# CITY OF CONWAY, ARKANSAS PLANNING COMMISSION

January 18, 2022

# Request for Preliminary Plat Approval - Bell Valley Subdivision Phase 4

# Request for Preliminary Plat Approval - Orchard Hill Subdivision Phase 3

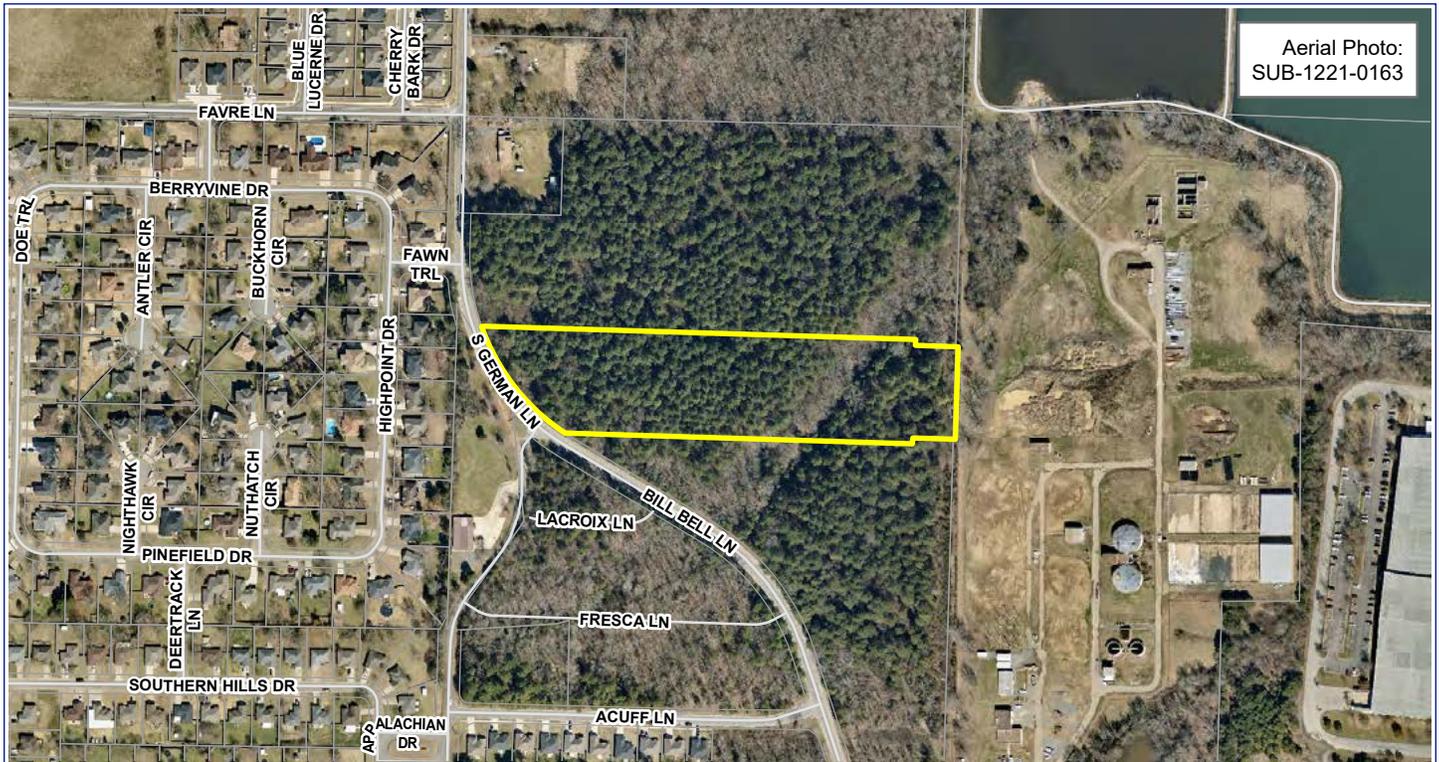
- The subdivision is designed so that no lots in this phase directly access Bill Bell Ln or South German Ln; a 10-foot planting easement is included along the frontages for these lots.
- The subdivision will connect to Phase 3, adjacent to the south; a stub out is provided for future connection to the north.

1. Show location of all fire hydrants.
2. Street names shall be proposed and availability confirmed with GIS Manager.
3. Drainage easement [shared by Lots 32 and 33] alignment revised to center on property line and/or easement increased to accomplish centering on property line.
4. Corrections as noted on the Preliminary Plat and Street & Drainage Plans as provided to the applicant.

5. Wheelchair ramps shall be installed by the developer/subdivider in accordance with the City of Conway Transportation Department Standard Details.
6. Sidewalks along the South German Ln and/or Bill Bell Ln frontages of Lot 53 and Lot 22 shall be constructed by the developer/subdivider, as the street is of a Collector classification, in accordance with the City of Conway Transportation Department Standard Details.

7. Lots 53 and 22 shall not take access from South German Ln/Bill Bell Ln.
8. The Street and Drainage Plans/Drainage Report shall be modified to meet the requirements necessary for approval by the City Engineer.

10. Fire hydrants must be placed so that the furthest point of a lot in a residential subdivision is not more than 600 feet from the hydrant located on the same street. Variances must be approved by the Planning Commission and Fire Chief.

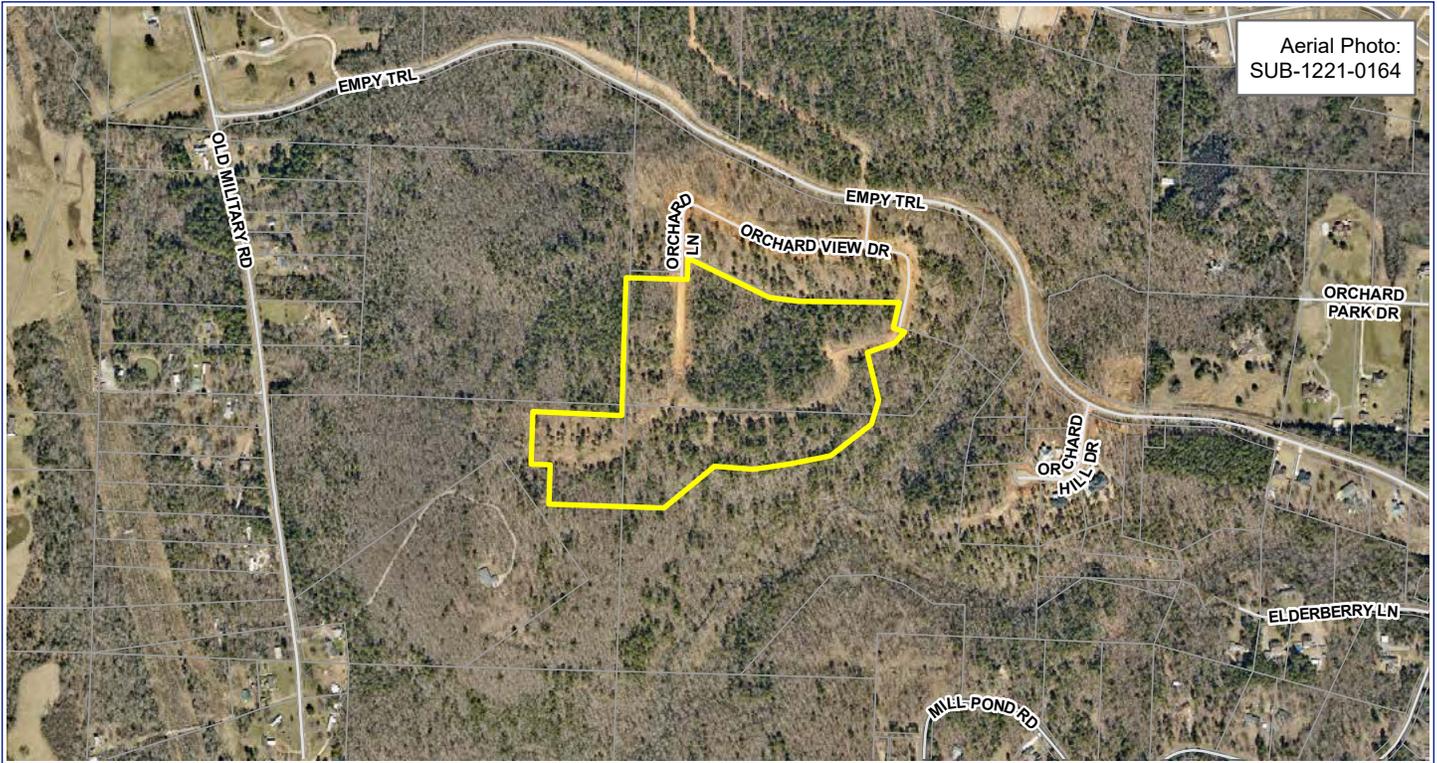
- The subdivision will connect to Phase 2, adjacent to the north. Two stub outs are provided for potential future connection to the west and south.
- Construction of a temporary fire apparatus turnaround is required at the stub street along the western boundary, until future street connection is established. If improvement is proposed on adjacent property, it must be placed in a recorded easement and referenced on the plat.
- Proposed stub to the south [between Lots 20-21] should be constructed as ROW, not indicated as an access easement, if future connection to the south is anticipated.
- Cul-de-sac design on unnamed street should be revised; lessen depth or consider addition of an island in center.

1. Show location of all fire hydrants.
2. Street names shall be proposed and availability confirmed with GIS Manager.
3. Hammerhead fire apparatus turnaround relocated or placed in a recorded easement and referenced on plat.
4. Cul-de-sac design should be revised. Applicant to coordinate with Transportation and Planning Departments to achieve an acceptable design.
5. Corrections as noted on the Preliminary Plat and Street & Drainage Plans as provided to the applicant.

6. If the property is annexed in the future, all construction commencing following annexation will be subject to in-lieu of sidewalk construction fees.

7. The Street and Drainage Plans/Drainage Report shall be modified to meet the requirements necessary for approval by the City Engineer.
8. A draft of a Bill of Assurance for the proposed subdivision describing proposed covenants, restrictions and conditions applicable to the property included in the submitted plat.

9. Fire hydrants must be placed so that the furthest point of a lot in a residential subdivision is not more than 600 feet from the hydrant located on the same street. Variances must be approved by the Planning Commission and Fire Chief.

1 ARCHITECTURAL SITE PLAN  
1" = 20'-0"

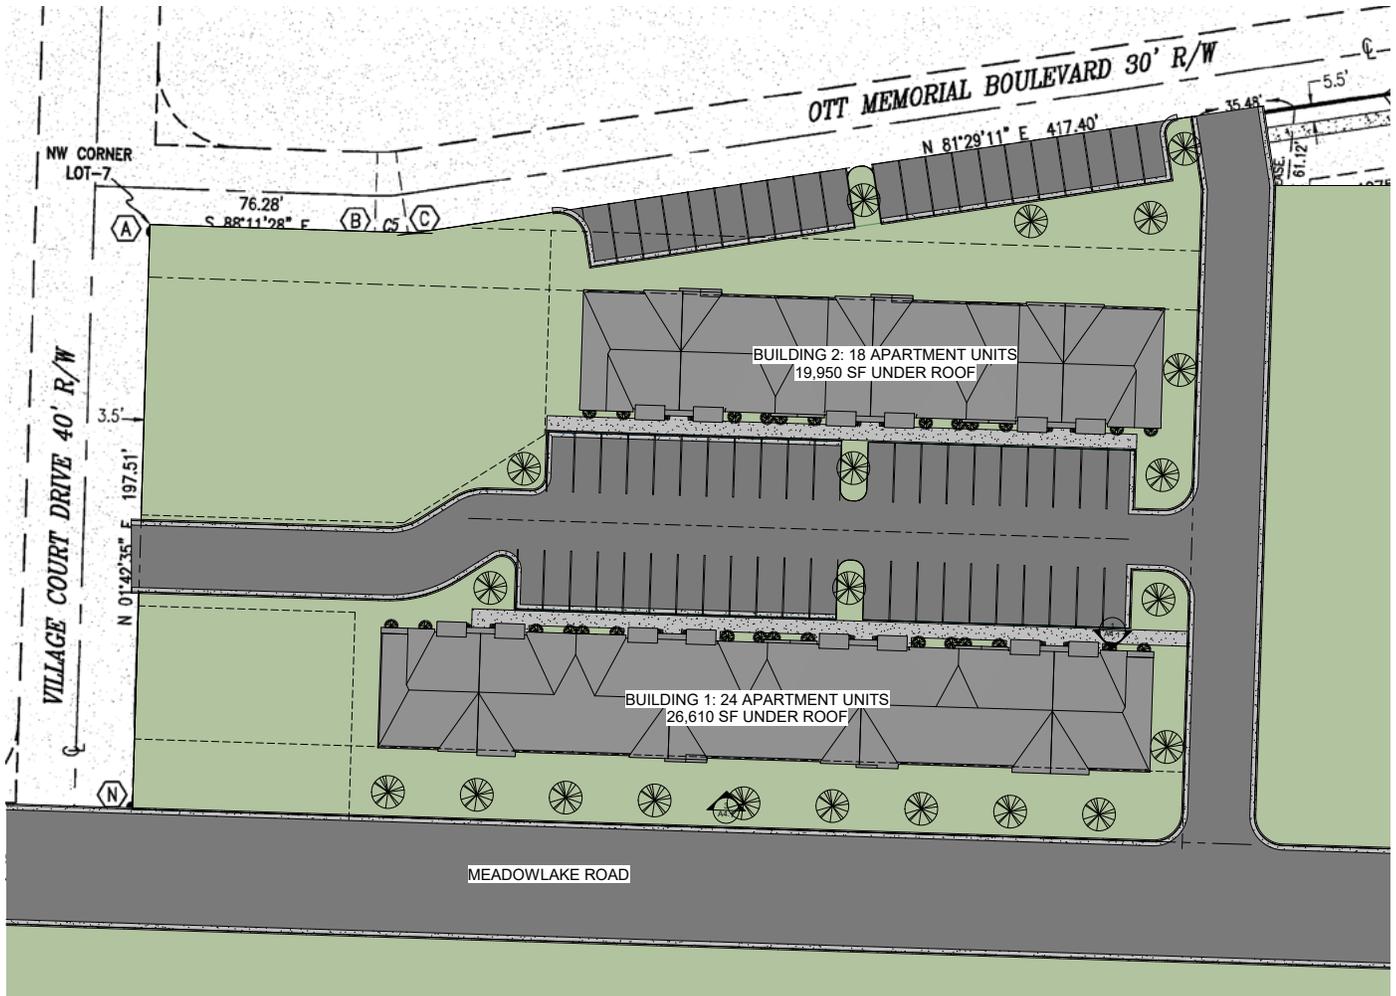
- The Comprehensive Plan designates the area as mixed-use. The amendment allows such development in a consistent manner with the plan.
- The applicant is seeking to modify the PUD to allow more multi-family development on the site. Currently, the PUD allows 80-85% to be occupied by single-family, town home, or apartment uses. The amendment as proposed would allow the entirety of Lot 7 to be devoted to residential use.

Staff recommends approval of the PUD modification as it is consistent with the Comprehensive Plan, would allow for appropriate use of the property in context to the surrounding area, and would not likely negatively impact adjacent properties. However, staff does not fully concur with the applicant's request. Below is staff's recommendation for the modification as well as a list of conditions for approval.

The PUD shall be amended such that the proposed amendments apply only to Lot 7C of the North Market Plaza Replat. All previous resubdivision of Lot 7 shall be governed by the PUD regulations previously established for Lot 7.

Buildings shall be located in a manner generally consistent with the architectural site plan and in accordance with the building lines established for Lot 7C on the North Market Plaza Replat filed in Book L, Page 55 with the Faulkner County Circuit Clerk. Outbuildings must be setback a minimum distance of twenty feet from the principal building. A minimum of ten feet shall separate all detached buildings.

The development shall provide vehicular and pedestrian connection to the existing access easement directly east of the property known as Cambridge Village Drive.
